Wauwatosa, WI

Board of Public Works

Meeting Agenda

Wednesday, September 24, 2025

1 ARCHITECTURAL SITE PLAN
Scale: 1/16" = 1'-0"

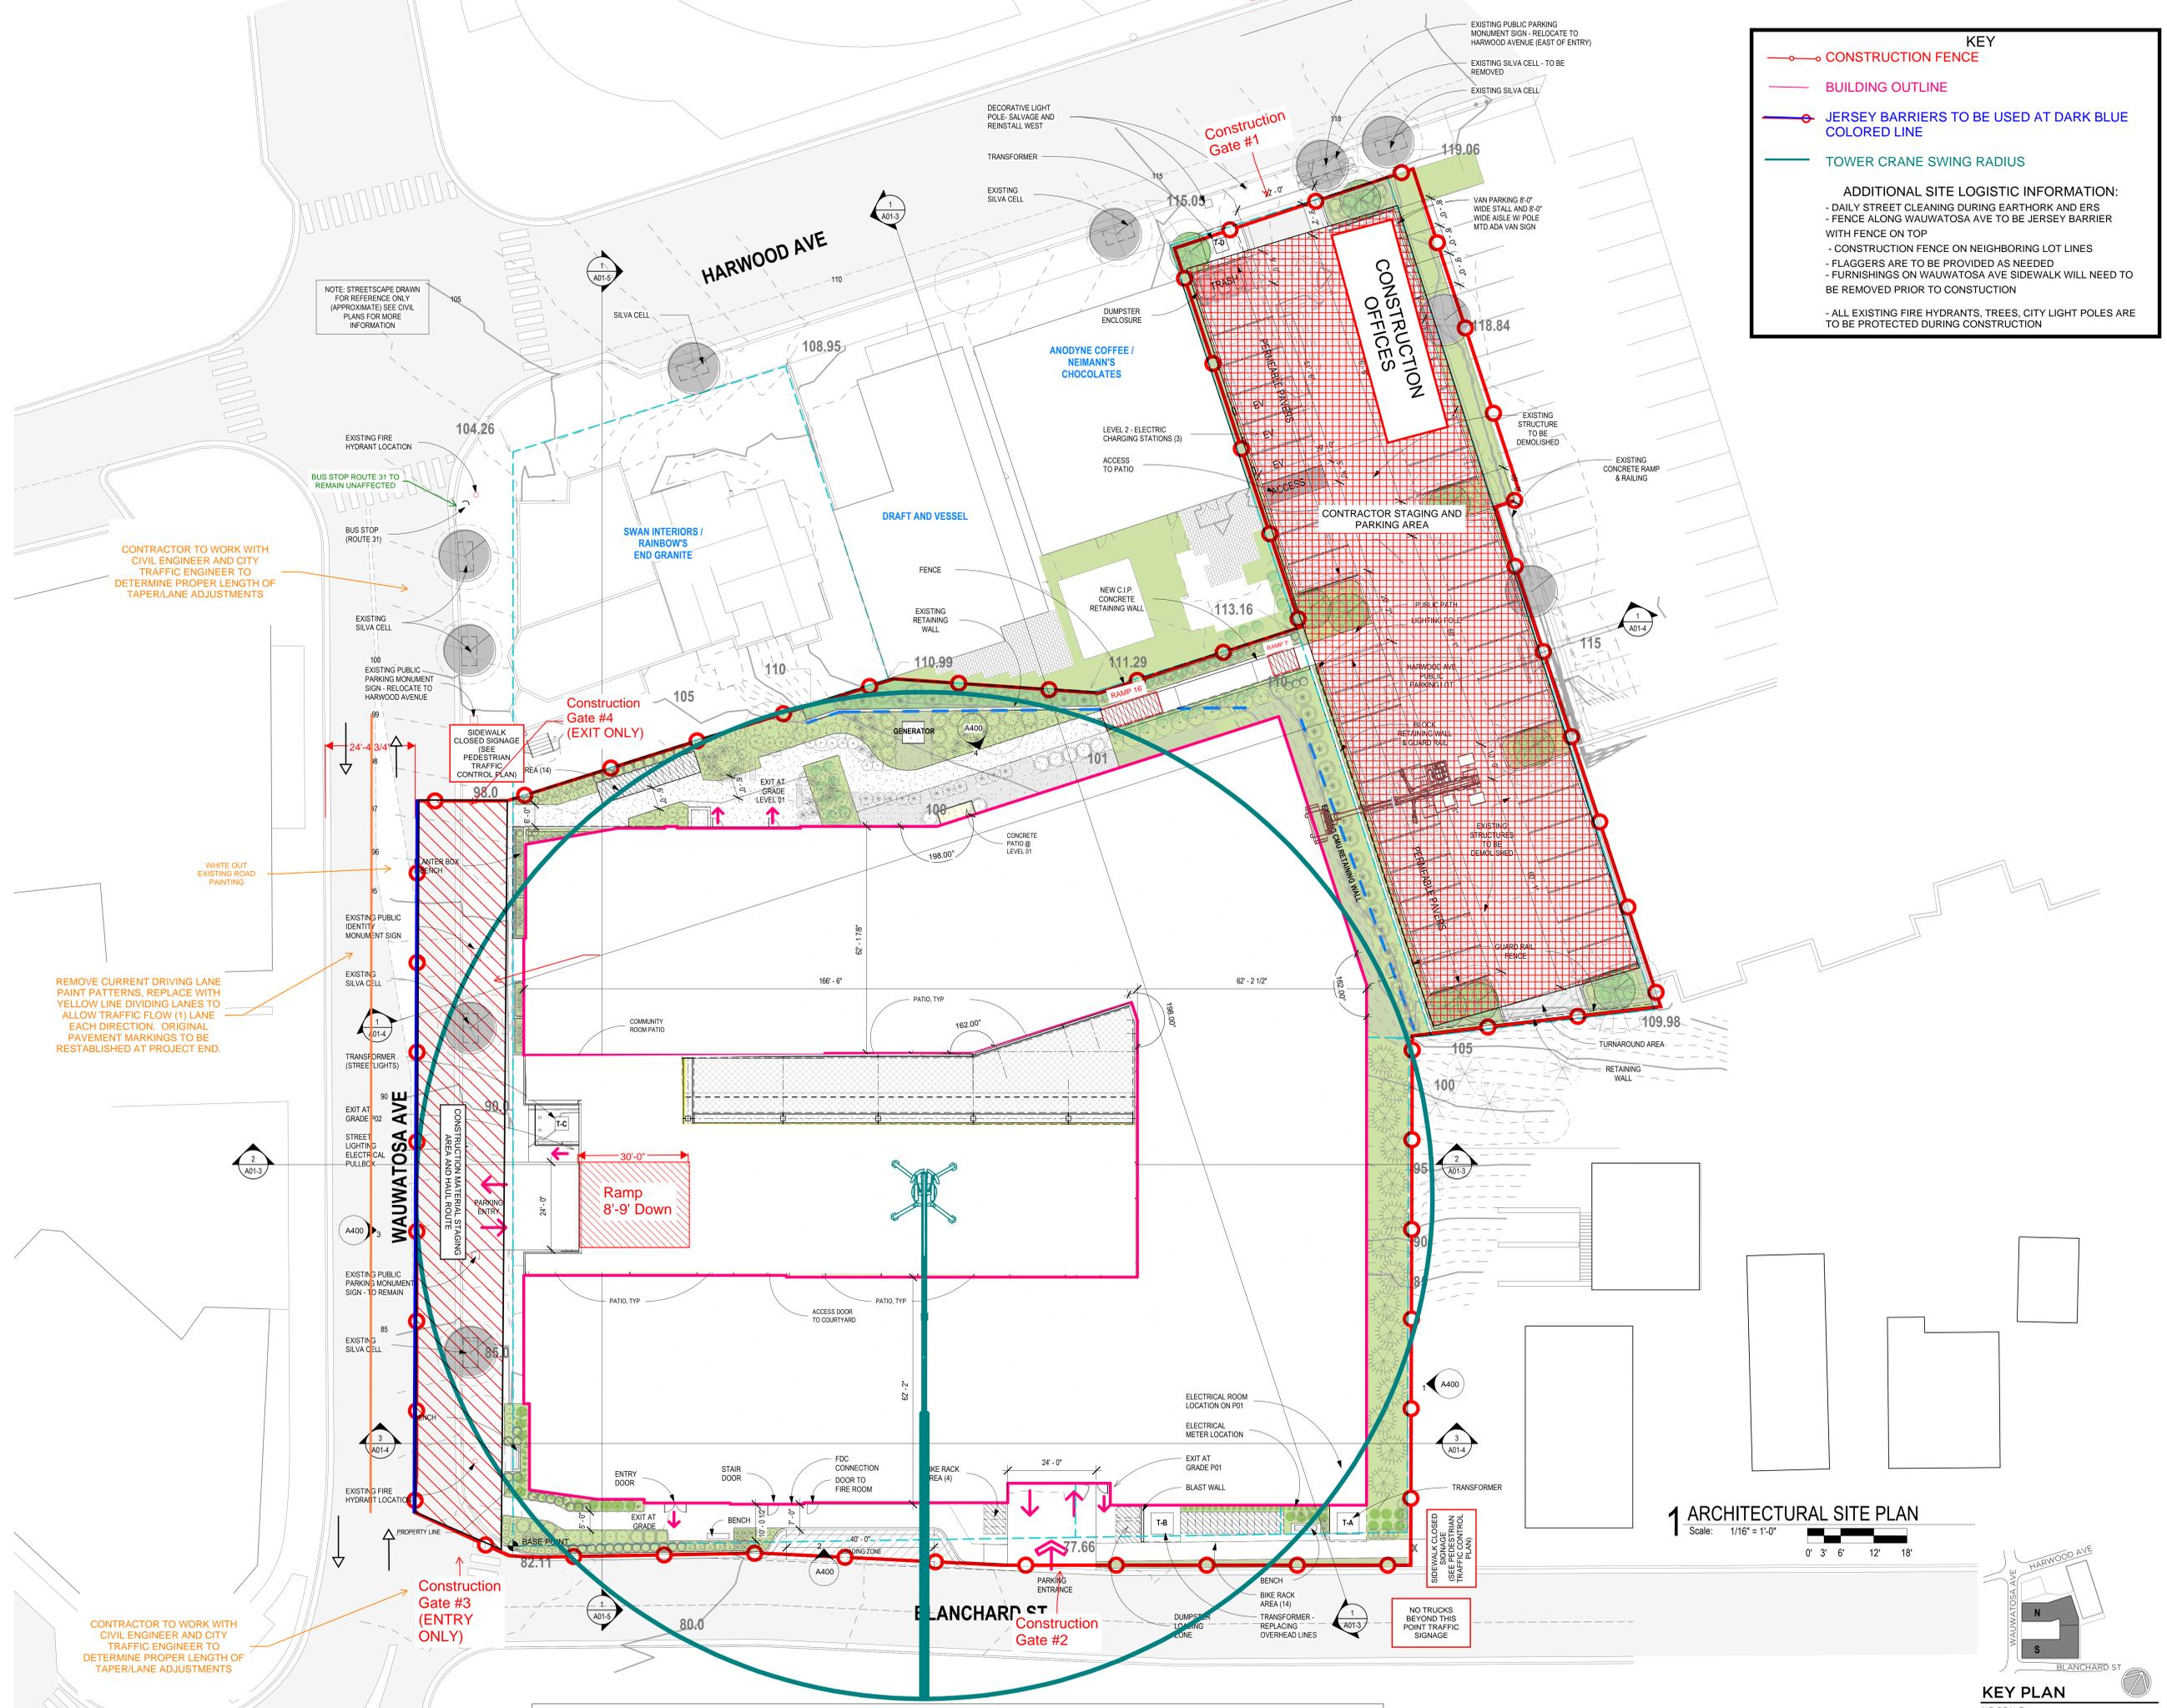
As shown in the attached site logistics plan, a construction material staging area and haul route is proposed directly adjacent to the property on the east side of Wauwatosa Ave in the existing northbound travel lane. The staging area/haul route will be separated from Wauwatosa Avenue vehicular traffic with jersey barriers and fencing. The main construction delivery entrance to the site is proposed at the northeast corner of Wauwatosa Avenue and Blanchard Street. Construction vehicles must enter in the site at this location via northbound Wauwatosa Avenue, travel one-way south to north and exit onto Wauwatosa Avenue via the northbound lanes. Engineering recommends that the contractor shall be responsible for the snow removal in the staging area/haul route.

The Wauwatosa Avenue center line will be shifted to the west to allow for one lane of traffic in each direction. Based on the proposed construction duration, it is required that all existing grooved in tape pavement marking will need to be ground off. Paint must be used to designate the temporary lane shift during construction. The pavement marking transitions to the north and south of the lane closure are subject to approval by Engineering. The applicant will be required to maintain all pavement marking during the construction duration. After construction is complete, the temporary paint must be removed and the pre-construction pavement marking re-established.

A construction gate/access point from Blanchard Street is also shown. No construction vehicles will be allowed to travel in Blanchard Street east of the property.

The site logistics plan also shows the proposed crane swing radius. The crane will be used for the construction of the proposed 5-story, 157-unit multi-family building. Engineering recommends that the Contractor name the

The applicant has also prepared the attached pedestrian traffic control plan for the proposed sidewalk closures on the east side of Wauwatosa Avenue and the north side of Blanchard Street. Due the long duration of the proposed sidewalk closure, Engineering will require that the pedestrian detour signs must be placed on poles installed in the grass near the back of existing sidewalk. Signage that is attached to the proposed construction fence is acceptable. Pedestrian signage must be placed in both directions of travel. The contractor will be held responsible for maintaining all sidewalk signage during the requested duration.

Engineering provided the attached construction staging plans to the Police and Fire Departments for their review. Because there is one fire hydrant located within the staging area/haul route that is essential to Fire operations in the Village, the Fire Department has requested that a fire location sign must be mounted on the construction fencing. The hydrant must also have at least 3 feet of clear space around the hydrant free of construction materials. Knox locks must be purchased for the construction gates so that the Fire Department can access the site during an emergency. The Police Department did not have any comments or concerns.

Staff recommends that the Board of Public Works grant the temporary construction staging measures within the public right-of-way for a 24-month time period. Approval is also recommended to be subject to the following:

- The Contractor naming the City as additional insured on the insurance policy for this project.
- The Contractor held responsible for snow removal within the delivery lane.
- Engineering approval of all construction staging, pedestrian detour, trucking routes, and Wauwatosa Avenue pavement marking modification drawings prior to Storage in the Right-of-Way permit issuance.
- The Contractor providing construction updates at the monthly Village BID meetings.

NEW SITE PLAN
 1" = 20'-0"

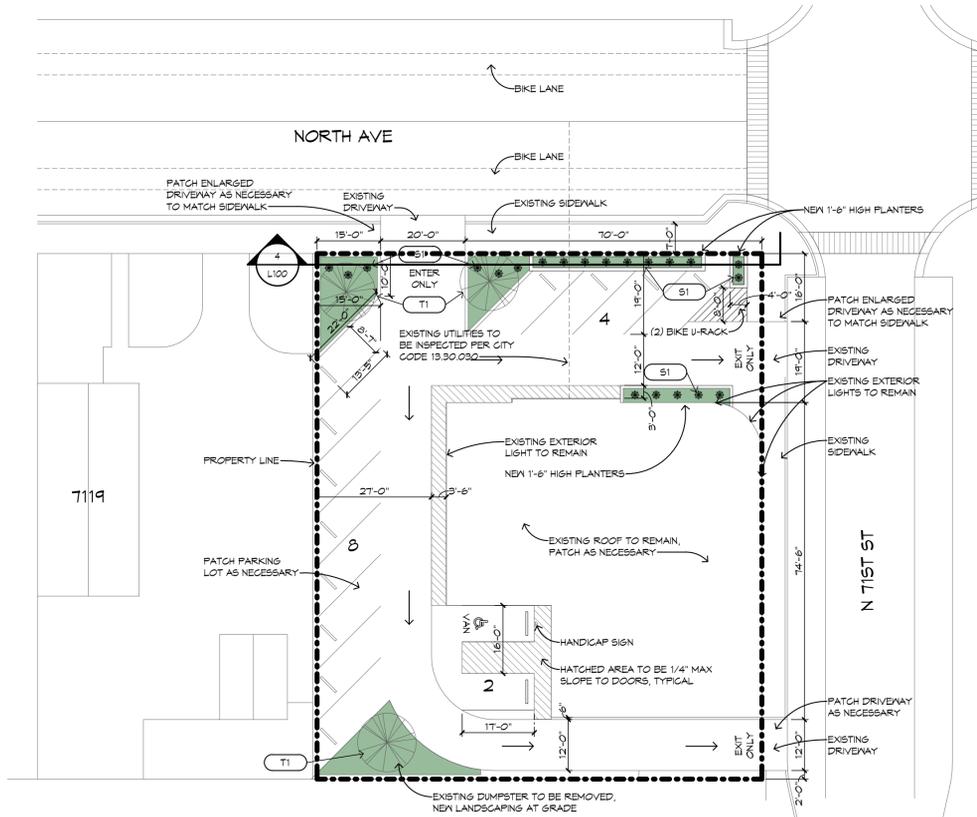
Approximately 32 feet out of the required 52 feet of perimeter adjacent to W. North Avenue does not provide the required 10-foot perimeter landscaping width. Within the 32 feet of non-compliant perimeter, the applicant has proposed a raised planter bed with a proposed width 1.75 feet. Based on 52 feet of perimeter length, 3 trees and 9 shrubs are required. The applicant has proposed to provide 2 trees and 16 shrubs. A raised planter bed is proposed in this area due to existing onsite environmental contamination.

The proposed landscaping plan shows a vehicular use area of 5,141 square feet. Per the Code, 514 square feet of interior landscaping must be provided with 3 trees. The proposed plan provides 353 square feet of interior landscaping (6.9% of the vehicular use area) with 1 tree. The 76 square feet of landscaping provided near the northwest corner of the building and the 126 square feet of landscaping provided at the W. North Ave entrance cannot be counted towards the interior landscaping requirement because it does not meet the minimum Code required 10 feet in width or 135 square feet of area.

Why do the proposed planters in the perimeter must be provided above grade?

The previously approved site plan from 1981 showed that there were 13 parking spaces. The proposed plan shows 14 parking spaces.

Our calculations show that the interior landscaping area that is being provided is 353 SF + 126 SF = 479 SF, or 9.3%.

I am concerned about how someone parking in the van accessible spot will be able to back out based on its close proximity to the building. Does a turning template show that a vehicle can safely back out of this spot if there are vehicles parked in the adjacent spot or across the drive aisle?

Could this area be reconfigured such that it is for van spot and access aisle only? The spots could then be moved south from the building and then angled to match what is being proposed on the other side of the access aisle. A small landscaping island could then be added in between the van spot and the building to get the overall site to meet the 10% requirement.

Response: The proposed 18” high planters along North Avenue were designed to be above grade to serve as both a barrier between the sidewalk and parking stalls, and to add additional good soil for the plantings above the contaminated soil identified in the DNR report. No requirements for a raised bed were identified in the Guide to Landscaping and Screening Code. If the planters are being classified as a fence under 15.28.030(B.1), we are willing to reduce the width of the planter by 18” to be compliant. If a raised planter is not desired by the board, we ask that we be given a variance on the guarantee for plantings located above the contaminated soil.

Response: The proposed project is for the auto shop to be replaced with a Flash Laundromat. The number of parking stalls within walking distance for a customer carrying laundry is directly tied to the financial viability of this use. If we are unable to gain any additional stalls from the (13) identified in the 1981 approved site plan, we will need to withdraw this application and either leave the site as-is or restore it to the 1981 condition, to be determined by the City of Wauwatosa.

Response: We would like to understand why the 76 sq ft of interior landscaping along the building does not count towards the calculation, and where else within the site would be counted. If a different location is identified that does not reduce the parking count, we will remove the landscaping in front of the building and add it in the desired location.

Response: A turning template using an 11'-6" interior and 19'-2" exterior radius was used during the drafting of the site plan and does clear the building and angled parking. In order to meet the clearances for a 14'-6" interior and 25'-6" exterior radius turning template, the van accessible stall would need to switch places with the second stall, and the second stall would be identified as a compact stall. If this change is desired, we will update the plan accordingly.

Response: If this area is reconfigured to be a van spot only, we would be reduced to (13) parking stalls and the site plan revisions would become infeasible.
